Author: Nick Scarr IP 20025524 10/10/21

This paper is a response to the Applicant's changing narrative regarding the importance of the Sizewell-Dunwich banks.

The Sizewell-Dunwich Banks. The purple arrows mark 26700N— to the north of which the crest height of Dunwich bank is lowering. Chart base format from [BEEMS Technical Report TR500 'Sizewell-Dunwich Bank Morphology and Variability'](#). Page 14. Markup my addition.

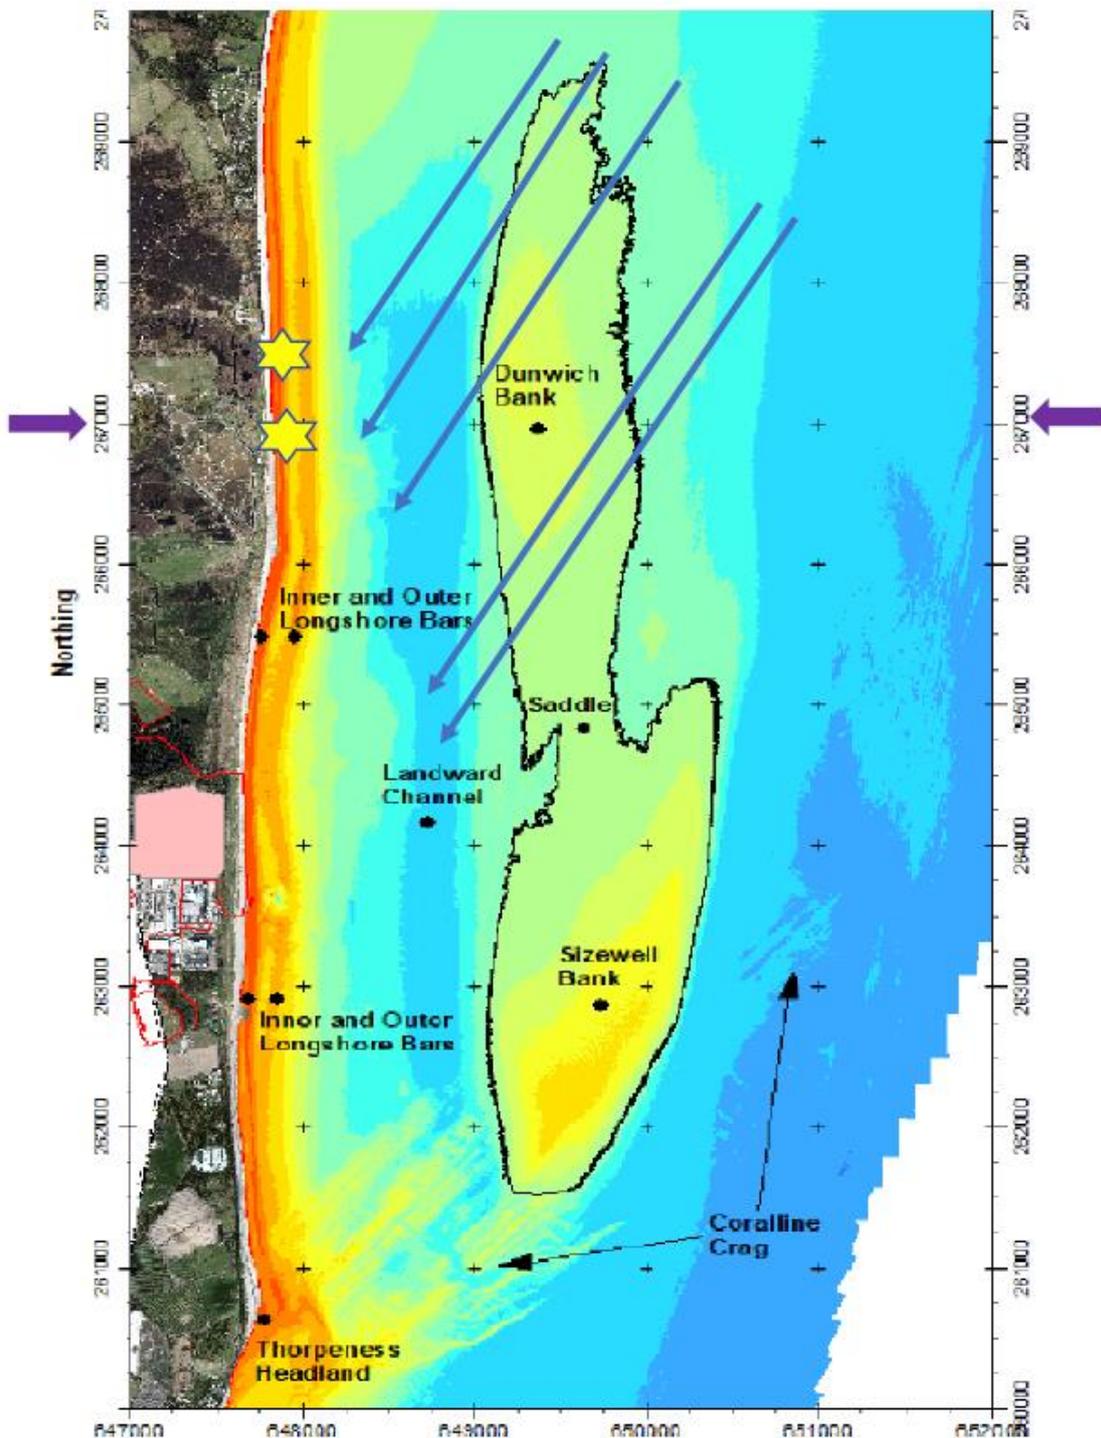
- Dunwich Cliffs are at the very Northern end of the Dunwich bank beyond 269000. Minsmere Cliffs approximately 268000, North of the yellow stars.
- The orange and red lines show the 'inner and outer' nearshore, longshore bars. The DCO provided detailed bathymetry of the inner and outer Longshore bars and not the Sizewell-Dunwich banks.

- The pink square shows the proposed location of Sizewell C.
- ***“Records over the last decade show...Dunwich Bank exhibited greater variability in both its morphology and position with erosion north of 267000N, [shown by the purple arrows] resulting in bank lowering of -0.5 to -1.5 m”*** [DCO: Geomorphology Appendix 20A, op cit., Page 21. BEEMS Technical Report TR500](#)).

- The five blue arrows show the direction of the most significant storm waves from the North/North-East— ***the largest and longest waves arrive from the N-NE sector. [1:100 wave heights 7.3m-7.8m]***. Waves from the NNE, NE and East are responsible for sudden and severe erosion on this stretch of coastline and are the most important to consider by far. The loss of the just the northern section of the bank could allow unbroken storm waves from these directions to break on the foreshore and increase water volumes in the South Minsmere levels in flood conditions.

- There has been net erosion of the foreshore in the area of the proposed Sizewell C since 1993 according to BEEMS Table 2. See [BEEMS TR223 op cit., Page 119 and Table 12 on page 115](#).

- The two yellow stars show the locations of breaches - 267400 15/12/03 and 14/2/05 and 266900 14/2/05. ***“This 200 m section is the most vulnerable stretch of coastline between Dunwich and Sizewell, and represents the most likely location of a major breach occurring during a future storm surge.”*** [Pye and Blott 2005, Coastal evolution RSPB op. cit., page 154 of 160. Page 28/160](#)
